Land North of Barkby Road, Syston
Response to Leicestershire County Council Highways
Comments 27th January 2023

1.2.1 This note has been produced in response to additional comments raised by LCC in their response of 27th January 2023 and discussions at a meeting held on 16th March 2023.

Planning Application Number: P/21/2639/2

JOB TITLE		System		CLIENT		Taylor Wimpey	
DRAWING TITLE							
Proposed Site Access Right Turn Lane Northern Site							
SCALE	DRAWN BY	DATE	DRAWING No	REVISION			
See Plan	BP	31-01-23	20060-02	F

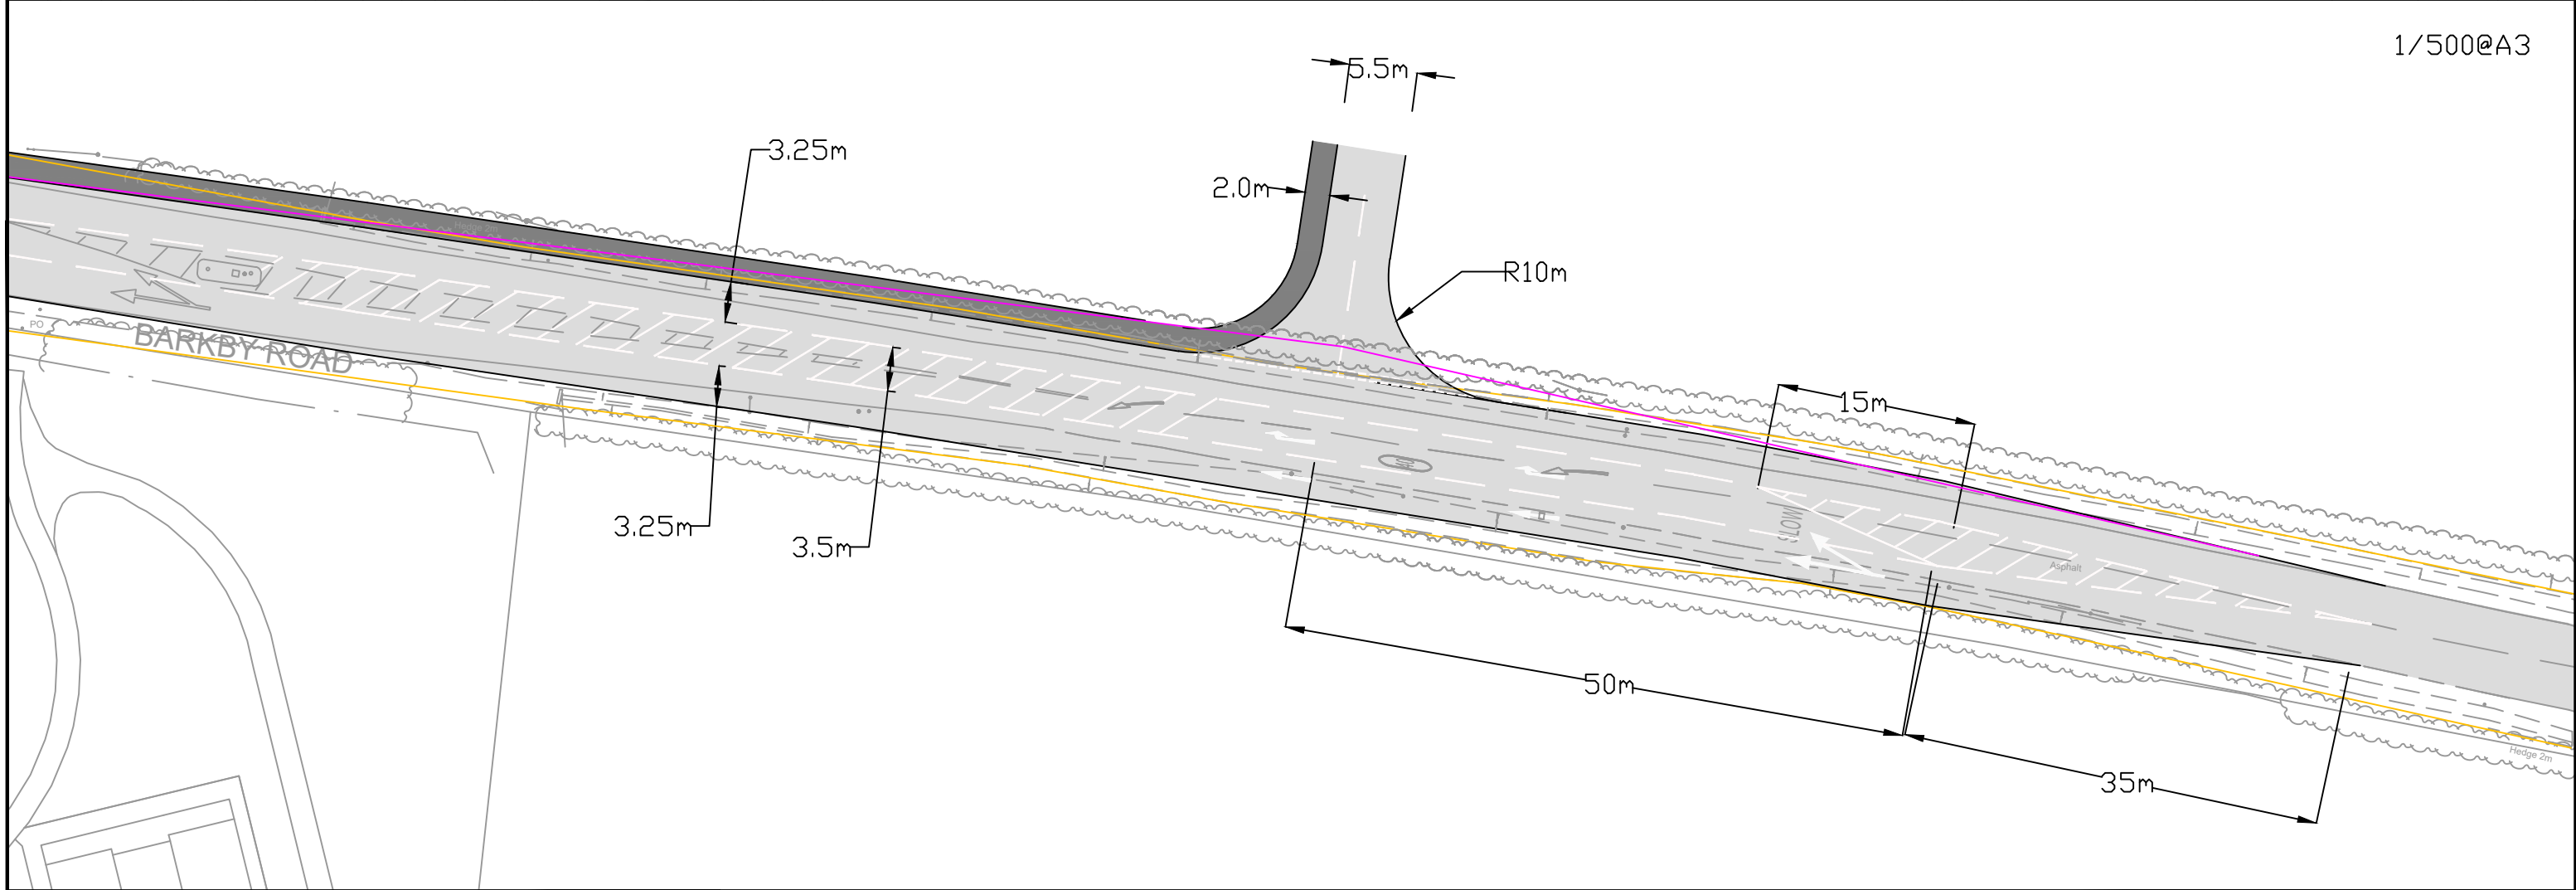
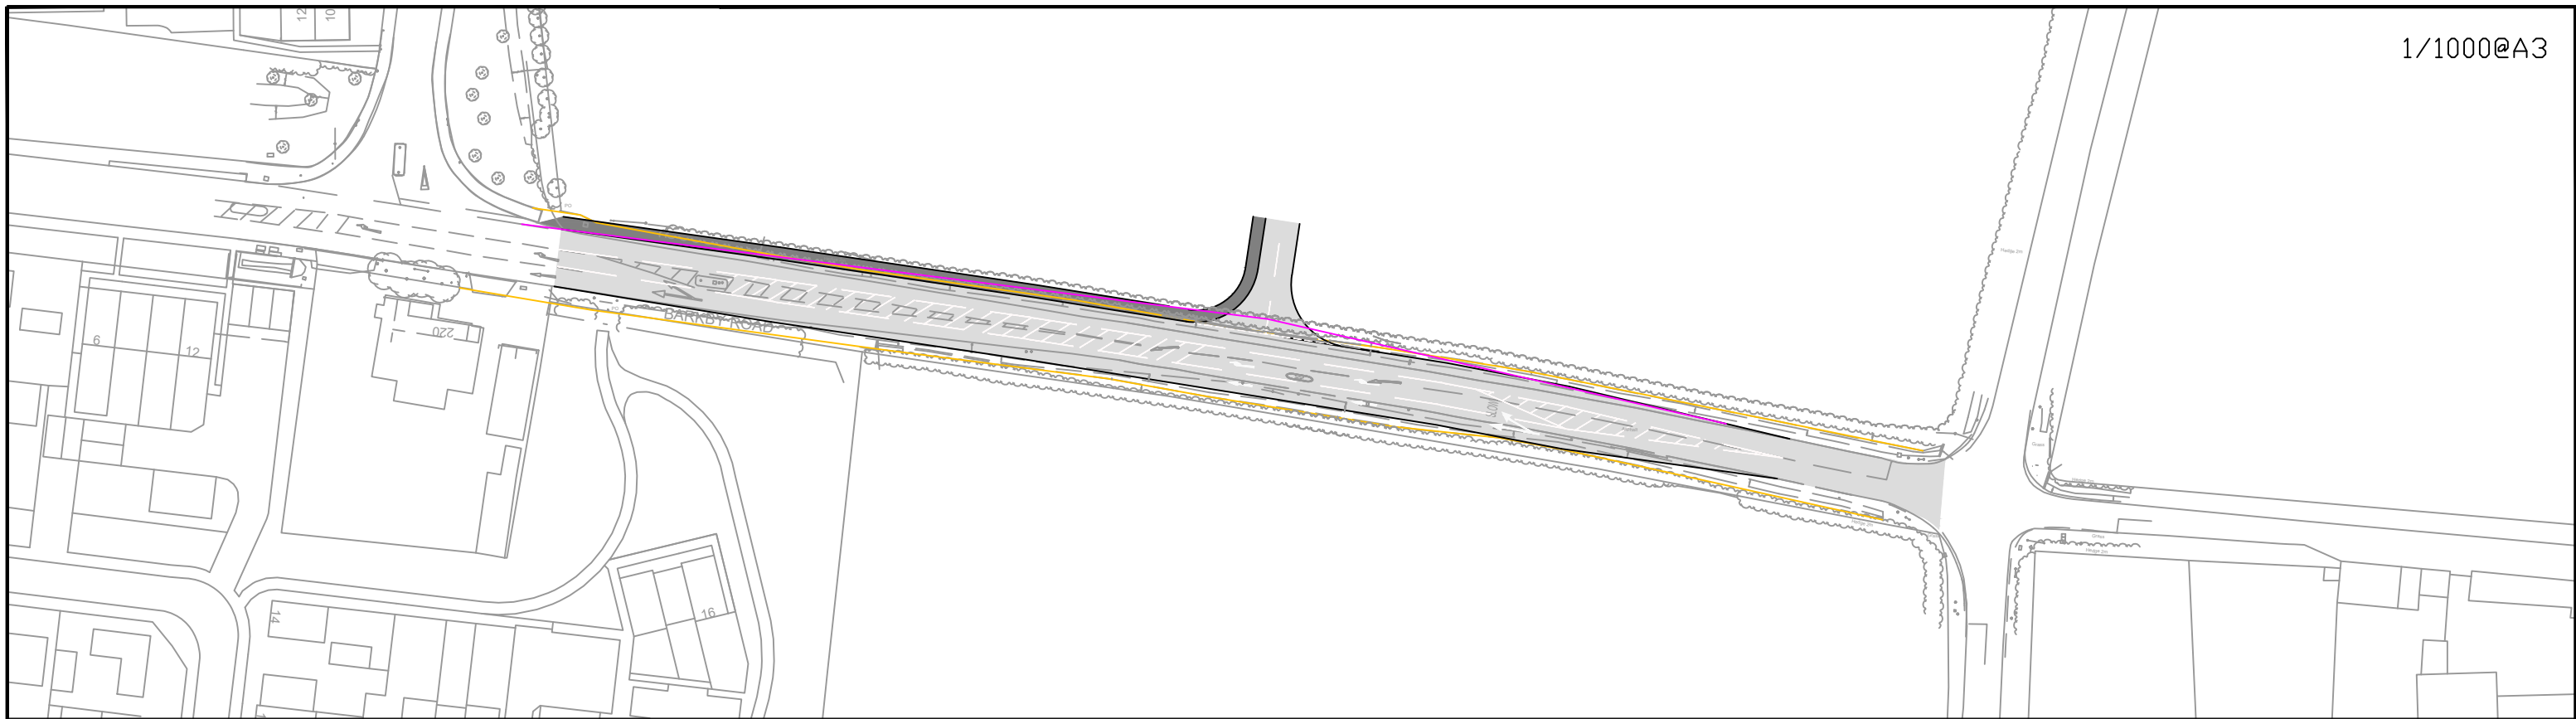
LCC have requested that the access design be revised to consider the requirements of CD116 in respect of lane widths, deceleration lane length and tapers.

As requested in its previous comments, the site access plan, drawing 20060-02 Rev D has been revised to include layout dimensions for the proposed ghost island and right turn lane provision, along with the proposed footway running adjacent to the kerb line. It should however be noted that the drawing indicates lane widths of 3.0m. Widths of 3.25m should ideally be provided for the through lanes along the bus route. The drawing indicates a 55m length for deceleration / turning / queuing lengths. This would meet CD116 requirements for a 70kph design speed, including an allowance of 5m for queuing length. However, the 55m distance should be measured to the centre line of the side road and not to the right turn arrow as shown.

The lane direction arrows are also located slightly too far beyond the centre line of the access road, and their locations need to be adjusted. No dimensions have been shown for the width of the right-turn lane and this needs to be indicated on the drawing. The taper length over which right-turn ghost island is developed also needs to be shown; this should be 1 in 20 as per CD116 Table 6.1.1 guidance. The LHA considers that the length shown on the drawing is too short. The LHA is concerned that the amendments to the design required would push the start of the central hatching closer to the existing junction with Queniborough Road. There will need to be sufficient space to fit the 1:20 taper in before the stop line, however this may not be achievable.

DTA response: The appropriate design standard for the right turn lane is CD123 and therefore is assumed that the LCC reference is to the roundabout overlay not the right turn lane.

For completeness, the site access plan, (**Drawing 20060-02 Rev F**) has been revised to include layout dimensions for the proposed ghost island and right turn lane provision. It was confirmed at the meeting on the 16th March 2023 that this arrangement is acceptable and agreed.

In terms of the lane widths these have been increased to 3.25m running lanes and a 3.5m wide right turn lane as per CD123 (Para 6.8 and 6.10 respectively).

The deceleration length (length b below) for a 70kph design speed (as in this instance) is set out in Table 5.22 is 40m. The turning length (a) should be 10m. A total of 50m is thus shown on the plan. No additional queue length is required as set out in the capacity assessments provided in the TA.

The length of the direct taper (e) is 15m.

The taper length is (as per Table 6.1.1) set at 1 in 20 and in accordance with Para 6.1.2 are developed symmetrically on the road, giving a taper of 35m long (1.75m x 1:20) either side of the central line.

Whilst modest tweaks have been provided to the layout, the form (and indeed interaction with the signal control junction) are the same as the previous version of the plan. There is therefore no fundamental change to the overall scheme and therefore no need to revisit the (agreed) Road Safety Audit.

JOB TITLE	System	CLIENT	Taylor Wimpey
DRAWING TITLE	Potential Future Roudabout Access		
SCALE	DRAWN BY	DATE	DRAWING No
1/1000@A3	BP	09-02-23	20060-06
REVISION	a

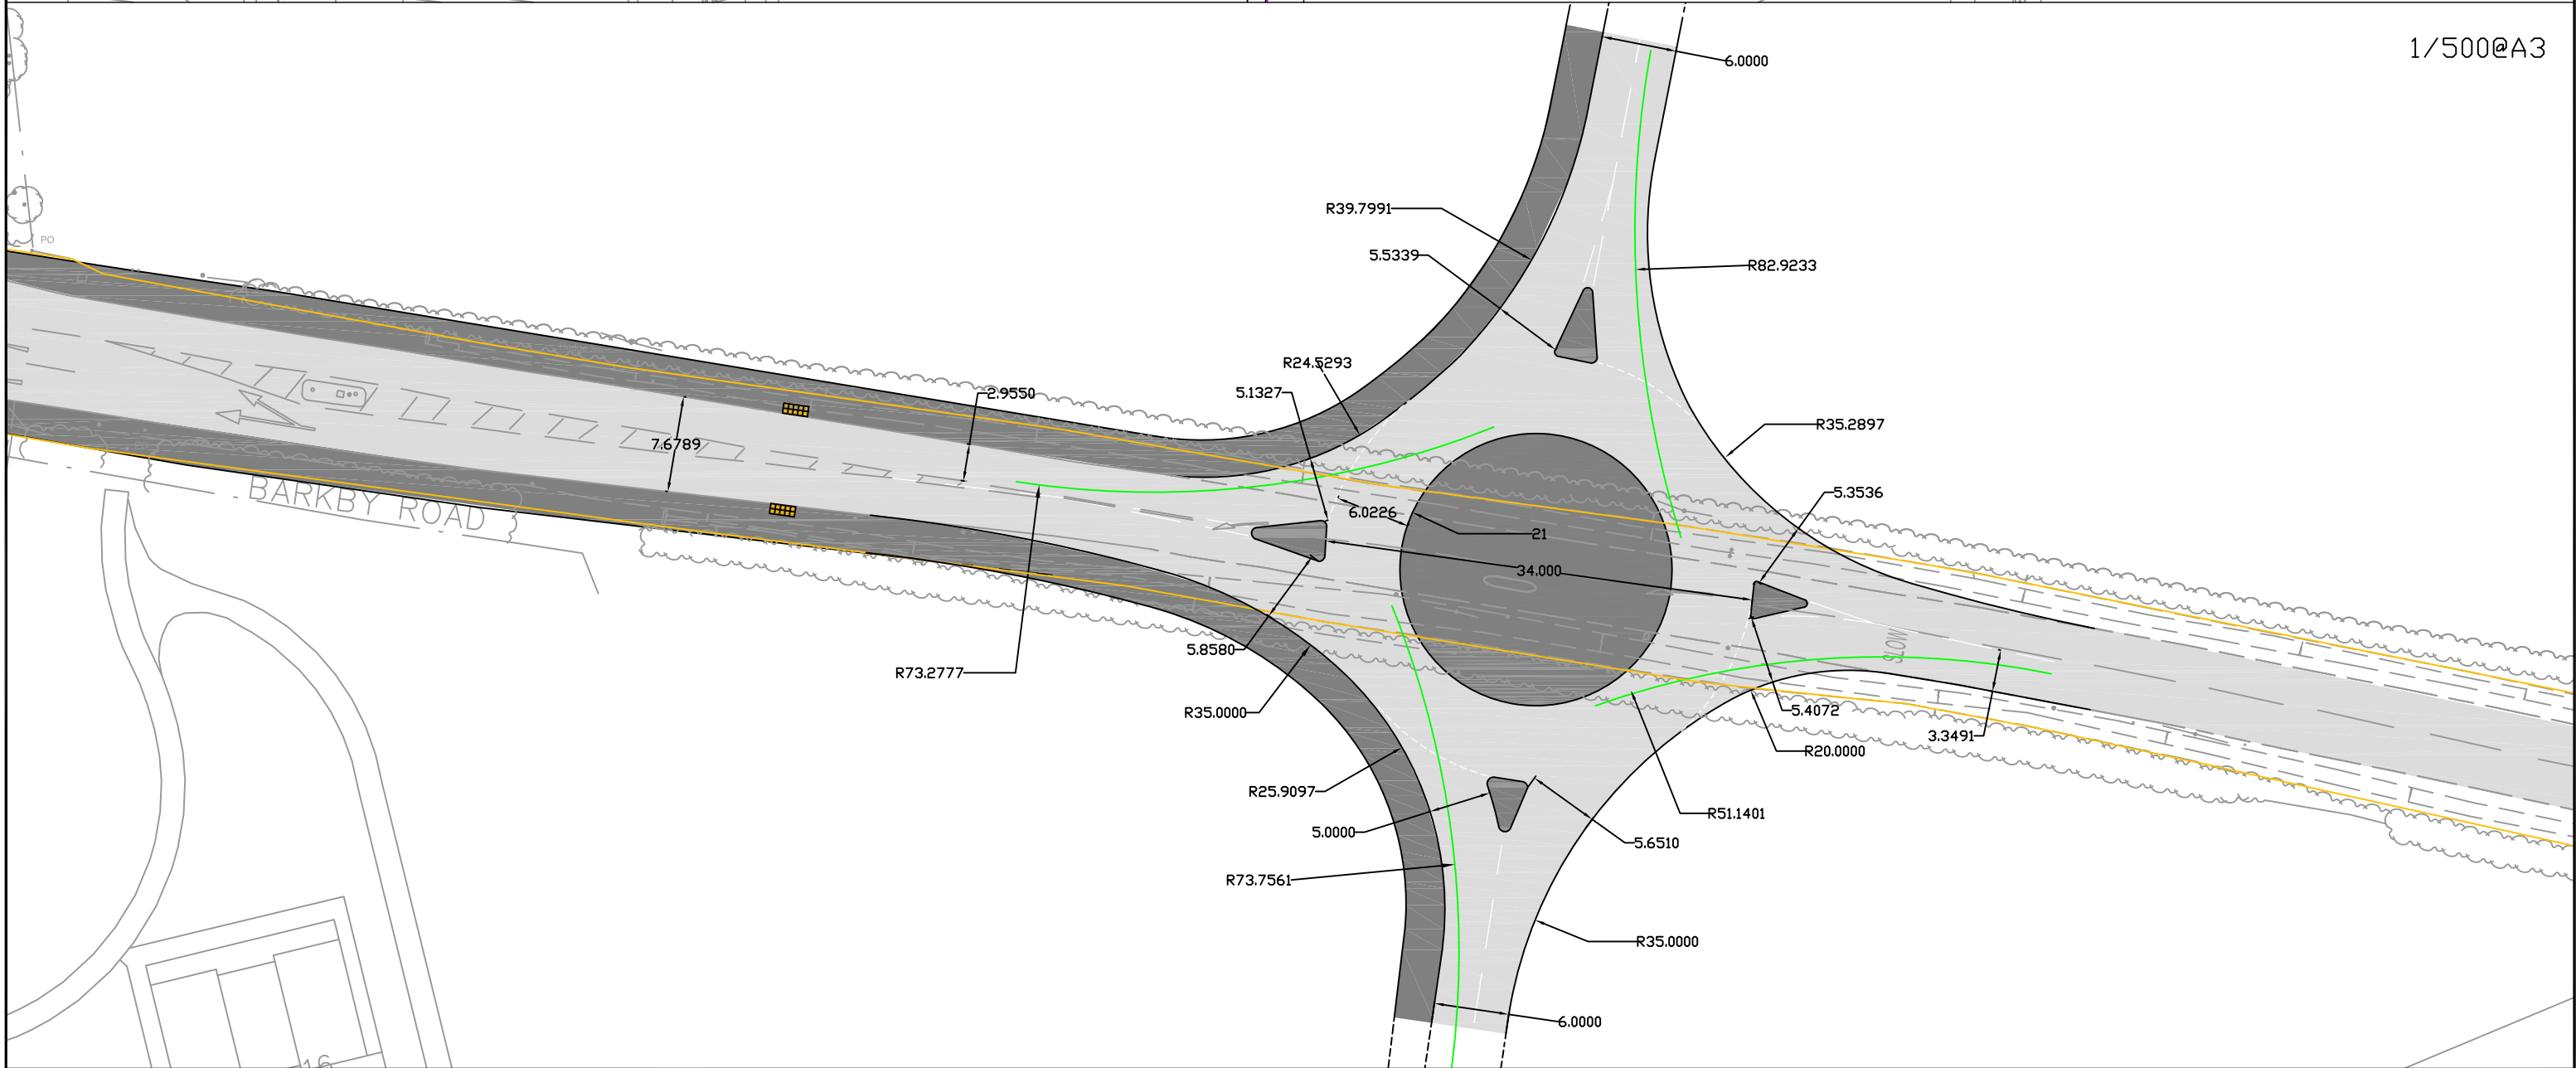
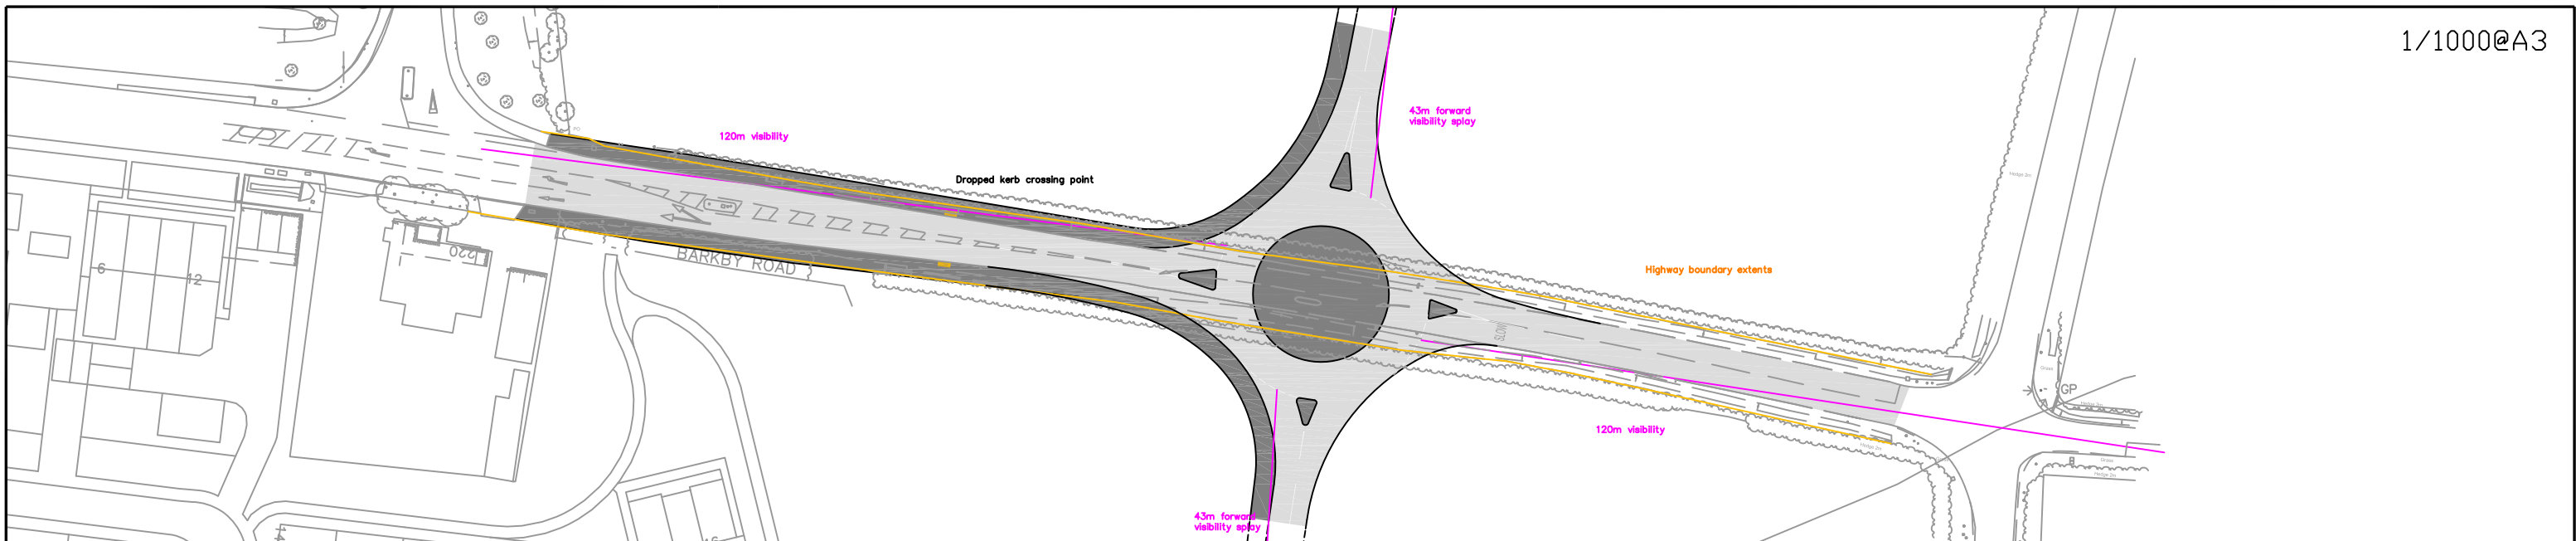
LCC have requested further design details of the roundabout shown on Drawing 20060-06.

The drawing indicates a proposed Inscribed Circle Diameter (ICD) of 34.0m for the roundabout layout. It would appear that a compact roundabout is being proposed but no dimensions have been provided for the central island diameter and overrun area, and these are required to be submitted for review. It is noted from the Roundabout Tracking drawing that a central overrun area may not be necessary, and if possible, this should be avoided.

Although no circulatory carriageway width information has been provided, it would appear that the circulatory carriageway is wider than CD116 para 3.6.8 guidance, in which case this should be amended accordingly.

Entry path curvature has been shown for the Barkby Road approaches to the roundabout, but not for the side road approaches, and these would also need to be submitted for review.

Further information for the geometrical design parameters of the roundabout is required to be submitted including entry widths, entry angles, exit widths, exit kerb radius and exit width tapers.

For the Barkby Road Eastbound approach to the roundabout, a stopping sight distance of 90m is shown to the give way line, however this would need to be 120m based on the 85th percentile speed measurements recorded for this direction. The Applicant should ensure that this is amended.

Forward visibility for the side road approaches to the roundabout also needs to be advised on the drawing.

No provision has been shown for pedestrian movements at the roundabout, and it is likely that the provision of footway to the Western side of the junction would be required across the Western arm.

Drawing 20060-06 was prepared at the request of LCC to demonstrate that the issuing of planning permission for this application and the associated proposed right turn lane would not prejudice the delivery of development to the south of Barkby Road (as included as Draft Allocation HA1).

We wish to make it absolutely clear that **Drawing 20060-06** was submitted for information purposes only and approval to it is not sought as part of this planning

The comments raised by LCC relate to detailed design matters (circulatory widths, entry path curvature and tracking). These are all matters which can be addressed as part of the future planning application for the land south of Barkby Road but for completeness the details are provided on **Drawing 20060-06 Rev A and 20060-06-2A**.

Clearly the submitted drawing does however demonstrate that there are no constraints to providing a compliant roundabout junction in the future. This was agreed at the meeting on the 16th March 2023.
